### MEMORANDUM

To: Development Review Board  
From: Mary O'Neil, AICP, Principal Planner  
Date: May 3, 2016: deferred to 6/7/2016  
RE: ZP16-0888CA; 100-102 North Union Street

**Request:** Appeal of an administrative denial to convert 200 sq. ft. of an existing attached shed to living space.

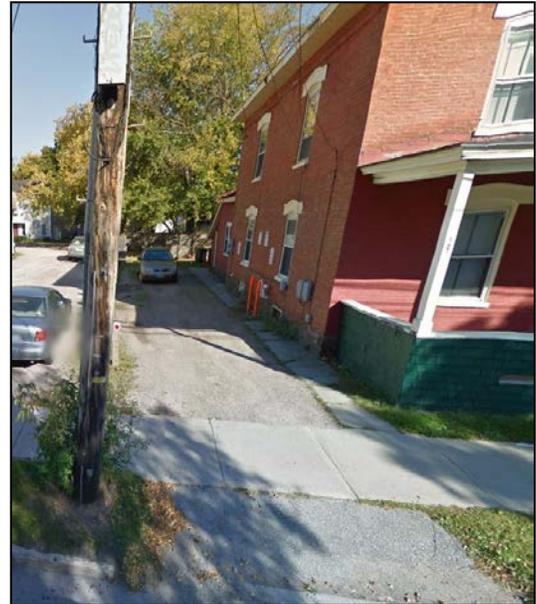
The proposed parking plan on the submitted site plan does not meet the required 5' minimum side yard setback. **Adverse finding.**

2. Scaled plan appears inaccurate (site plan scales lot width as 61'; tax maps identify lot width as 56.32'). No survey was provided to confirm parking adequacy or required setbacks on the parcel. **Adverse finding.**
